***Development Special Use Permit #2022-10018  
Vacation #2022-00002  
Restaurant Depot, 4600 Eisenhower Avenue***

<b>Purpose of Application</b>
Consideration of a request to amend to DSUP#2009-0003 for a new development special use permit and site plan, with modifications, to construct a 27,123 GSF expansion to an existing building; and a request to vacate approximately .72 acres (31,314 SF) of City right-of-way.
<b>Special Use Permits and Modifications Requested:</b>
<ol style="list-style-type: none"> <li>1. Development Special Use Permit amendment to DSUP#2009-0003 for expansion to a wholesale facility within the OCM 100 Zone, with modifications, and,</li> <li>2. Vacation of public right-of-way.</li> </ol>

Attachment 1: Applicant exhibit for 10' shared use path, dated 9/12/22

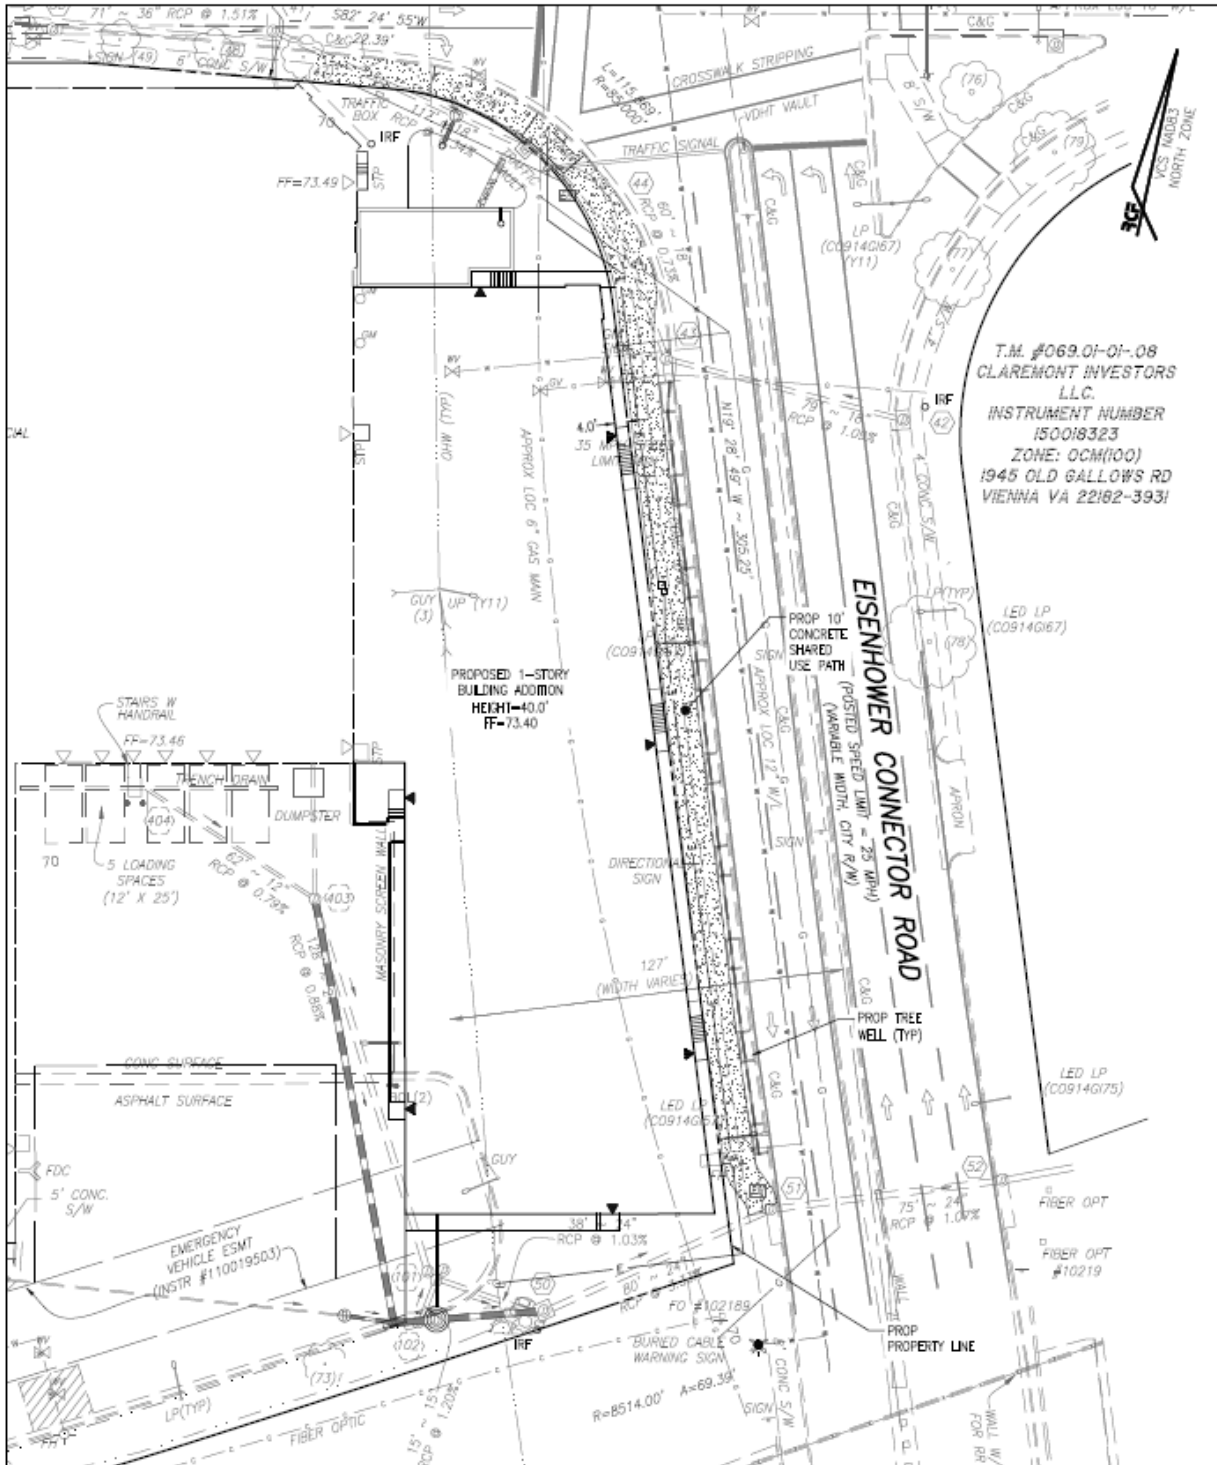
The applicant initially proposed a six-foot sidewalk with nine new street trees for the Eisenhower Connector frontage, and staff supported the design. In August, staff was informed by Fairfax County of planned improvements to some of their on-street bike facilities, to the south of the project site. Staff revisited the question of bike infrastructure along the Connector frontage, and the applicant agreed to adjust the streetscape as generally shown in *Attachment 1*. They will widen the proposed sidewalk from a six-foot pedestrian path to a ten-foot multimodal trail, while retaining the proposed street trees.
